Product Change Notice

Issue Date: 06 February 2013

Introduction of new die source for High Brightness SMT AlInGaP LED Lamps

Parameter	Existing die source	New die source
Maximum LED Junction Temperature	130°C	110°C
Maximum Forward Current vs Ambient Temperature

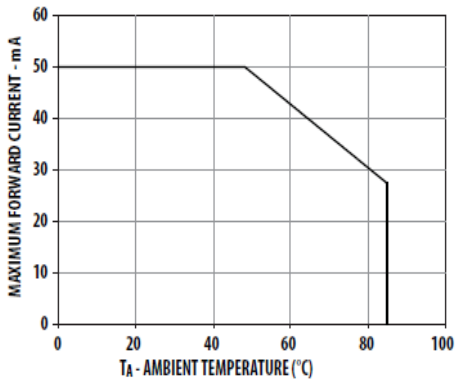
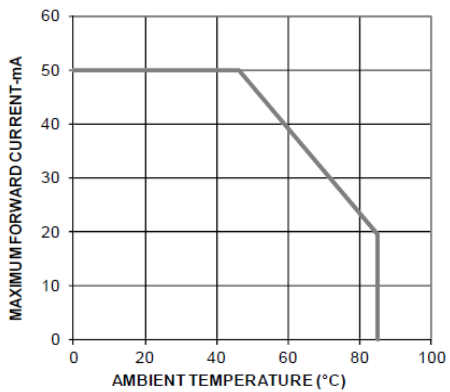
The selected die source is qualified per Avago's qualification process. Below are the changes on product performance incorporating with selected new die source.

Shipment may contain both die sources starting 06-March 2013. No sorting is required. Customer is advised to refer to the new derating curve effective immediately.
